Addendum 47 – UN Regulation No. 48

Revision 13 - Amendment 3

08 series of amendments – Date of entry into force: 22 June 2022

Uniform provisions concerning the approval of vehicles with regard to the installation of lighting and light-signalling devices

Model A

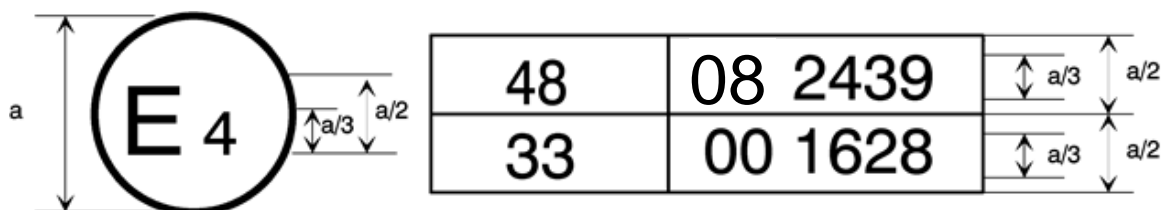
Annex 2, amend to read:

The above approval mark affixed to a vehicle shows that the vehicle type concerned has, with regard to the installation of lighting and light-signalling devices, been approved in the Netherlands (E 4) pursuant to UN Regulation No. 48 as amended by the 08 series of amendments. The approval number indicates that the approval was granted in accordance with the requirements of UN Regulation No. 48 as amended by the 08 series of amendments.
